Product Change Notification / SYST-28CLNB029

ERRATA - PIC18(L)F27/47K40 Family Silicon Errata and Data Sheet Clarifications Revision

Description of Change: Removed 2.1.2. Added silicon errata 2.1.6, 2.1.7, 2.1.8, 2.4.2, 2.5.3, 2.10.1, 2.11.1, 2.12.1. Removed Data Sheet clarification for Operating speed. Modified 3.2.1 (Electrical Specification) ADC Offset Error updated to -+3.0LSb.

PIC18(L)F27/47K40 Family Silicon Errata and Data Sheet Clarifications

Figure 1. 28-pin SPDIP, SSOP, SOIC

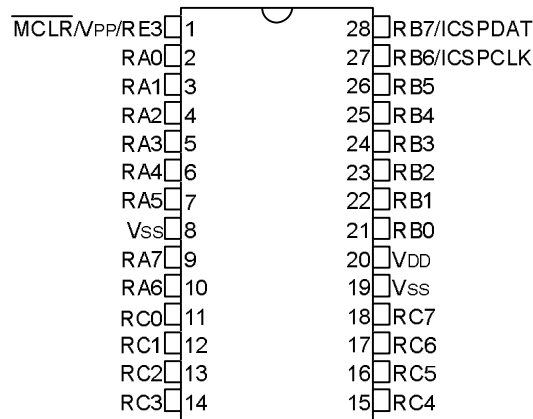
The correct marking for pin 26 on the 28-pin SPDIP/SSOP/SOIC package is **RB5**.

Figure 3. 40-pin PDIP

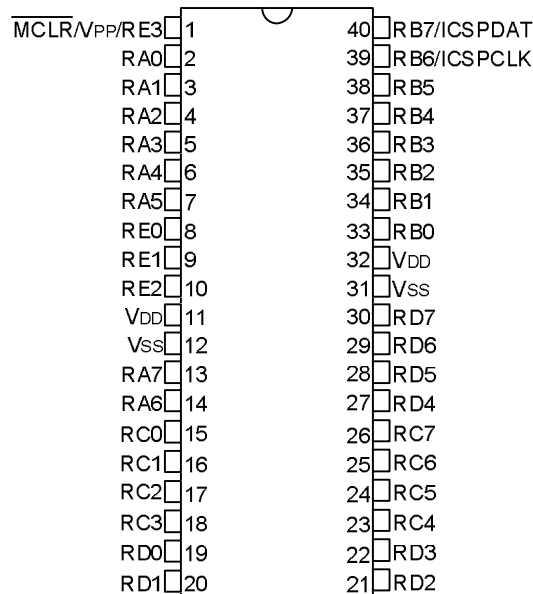
The correct marking for pin 38 on the 40-pin SPDIP package is **RB5**.

Figure 38-10: ADC Conversion Timing (ADC Clock F_{OSC} -Based)

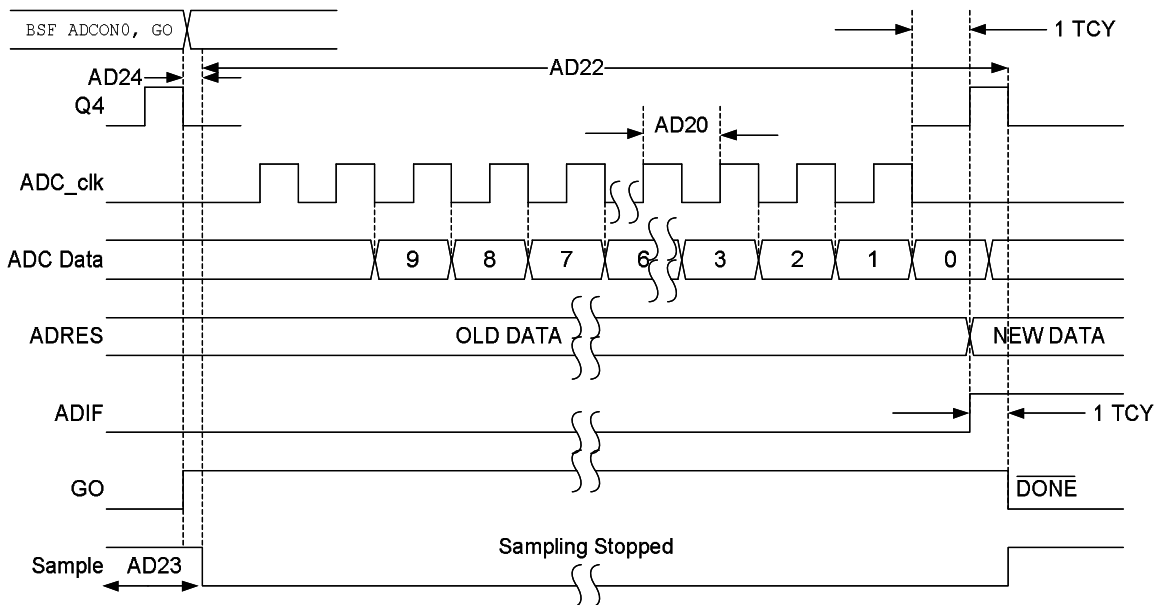
Refer to the images below for corrections of Figure 38-10 and Figure 38-11. Previously, the parameter numbers were incorrect.
